Re: Townhouses on 32-34 Washington Avenue
Revised Documents for review by the Planning Board

Summary of Response to Planning Board Comments 5-21-15

Summary of Response to Planning Board Comments 7-1-15

A-11

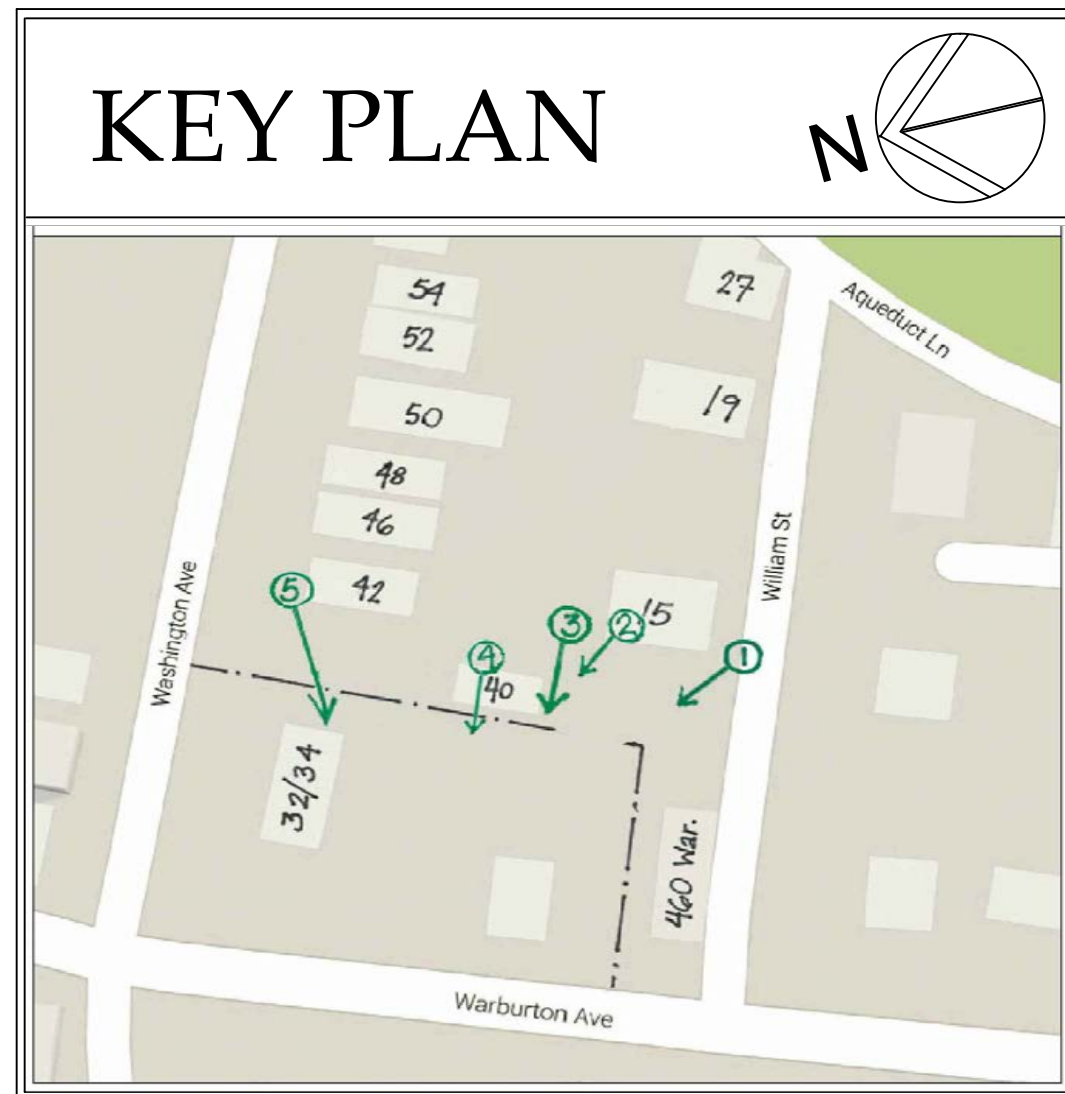
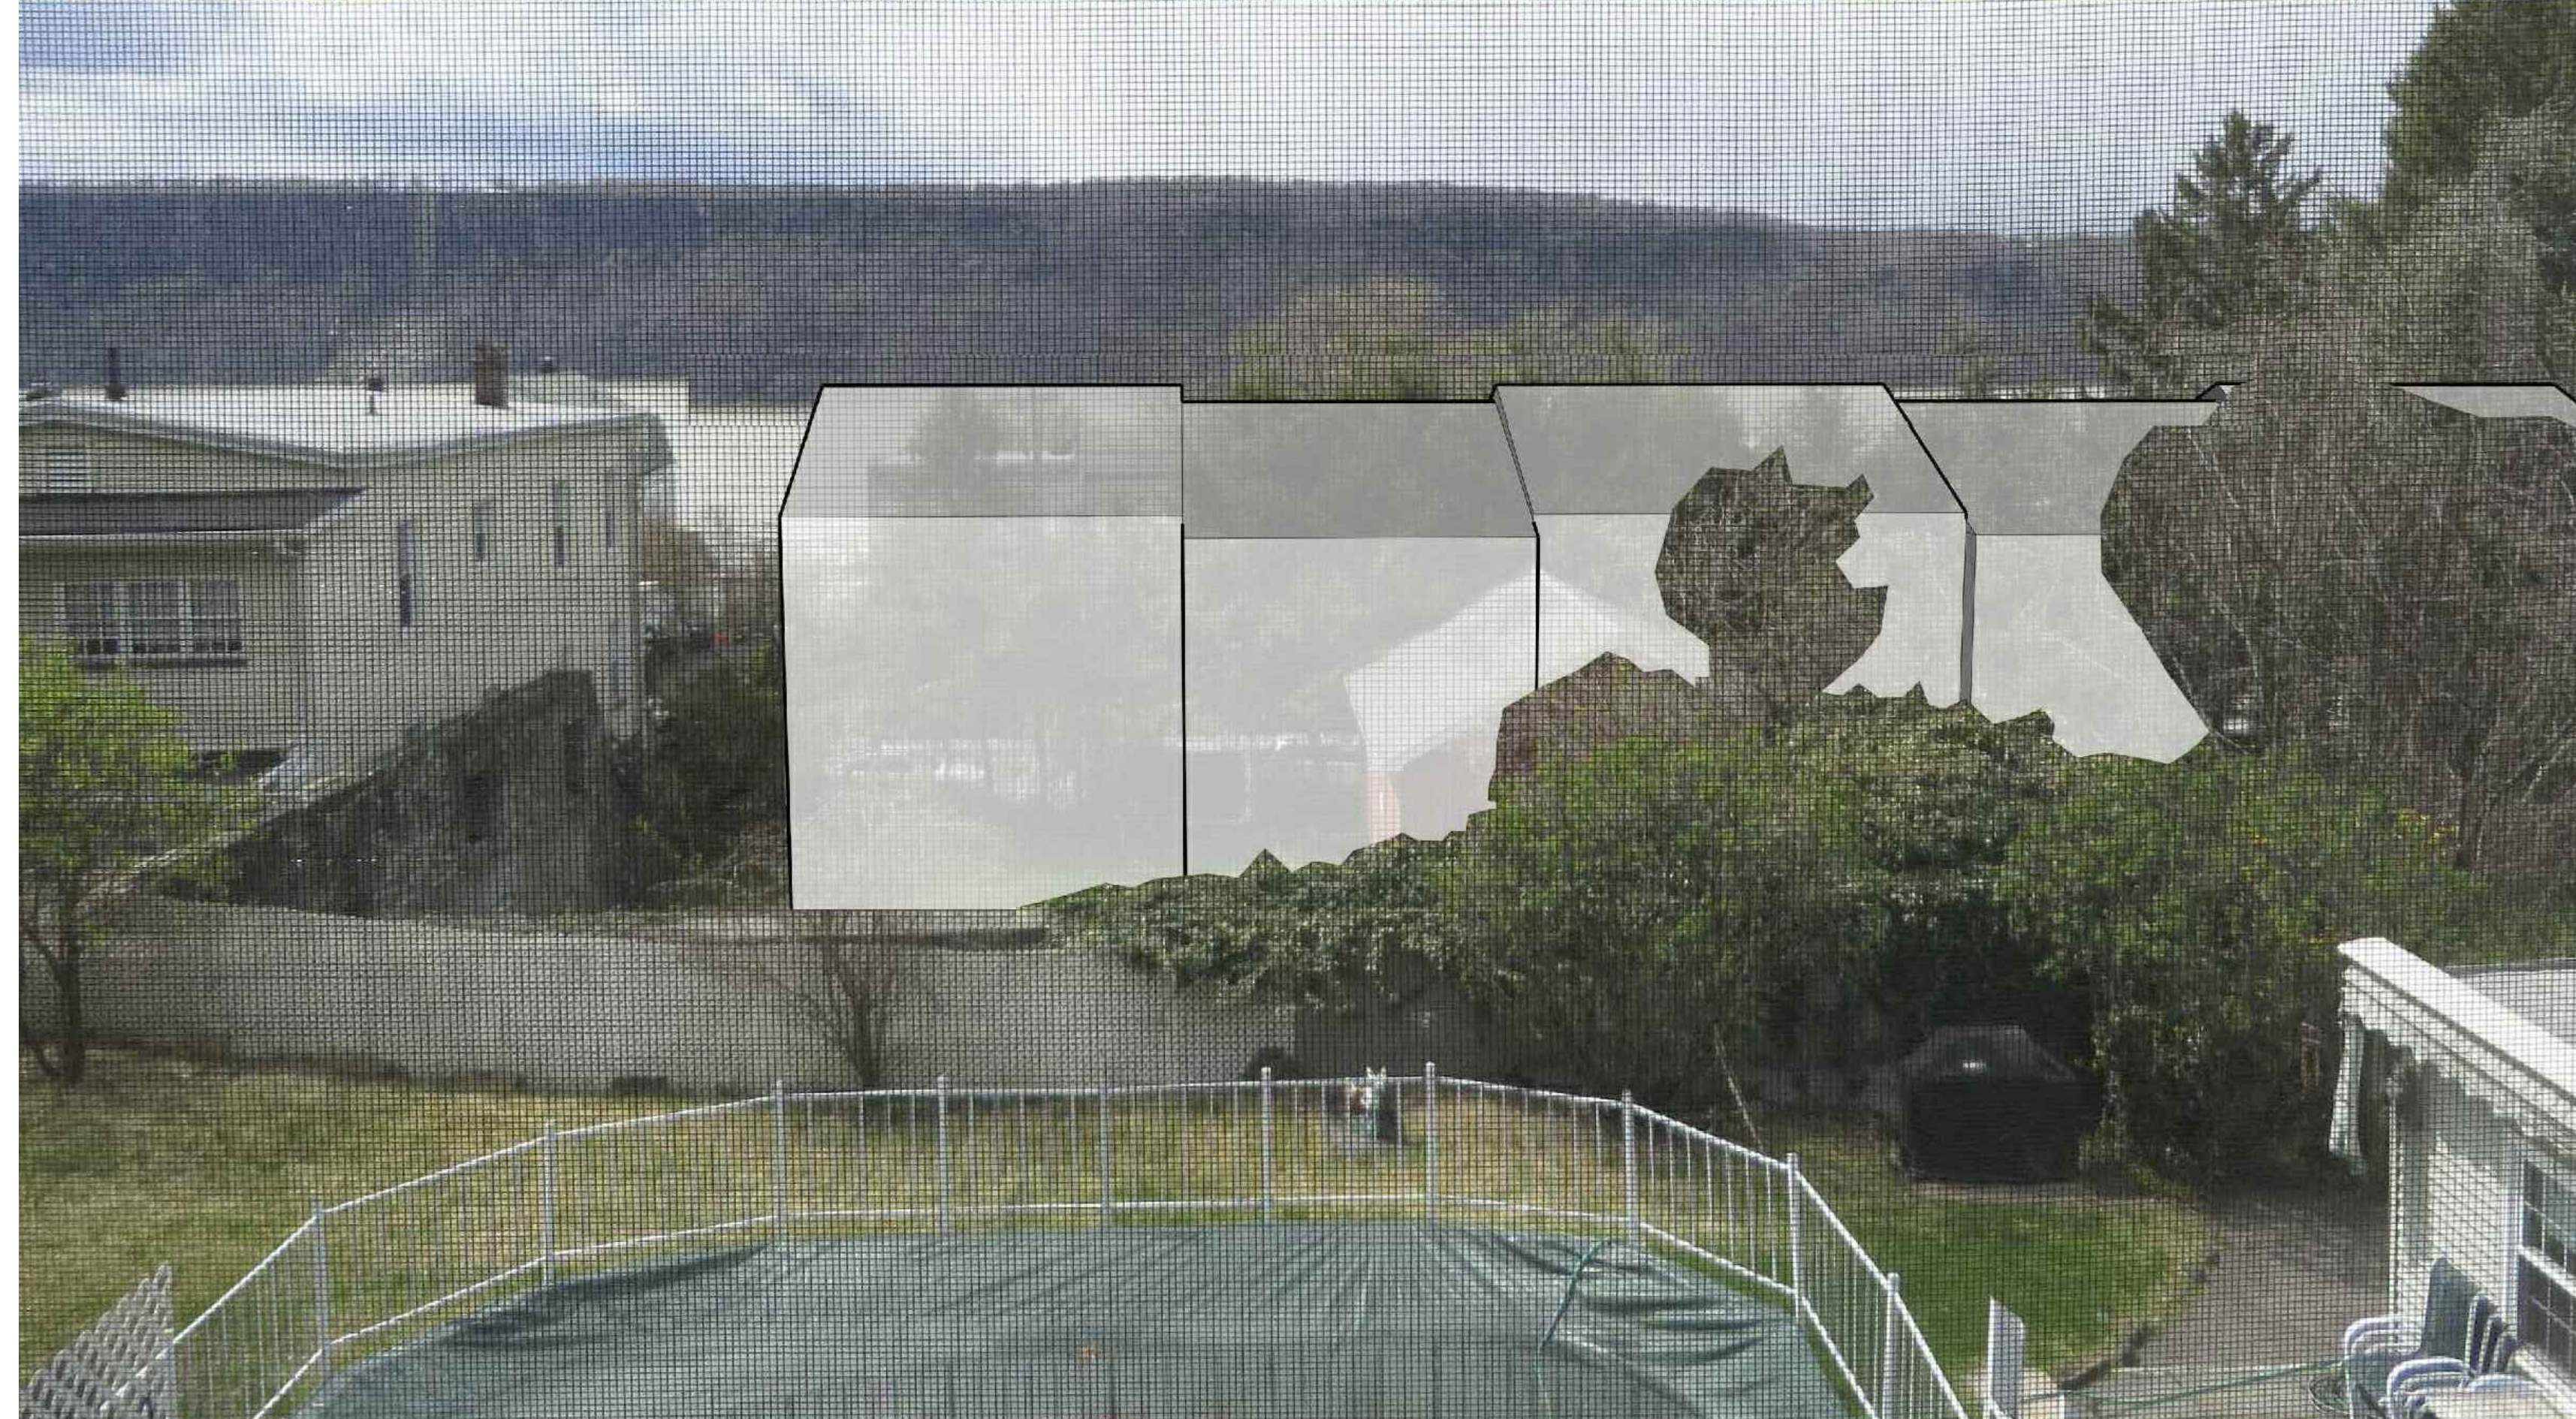
6. Additional view analysis, drawing A-11, dated 6-30-15, provided to show views from second floor of 15 William Street, as requested by neighbor
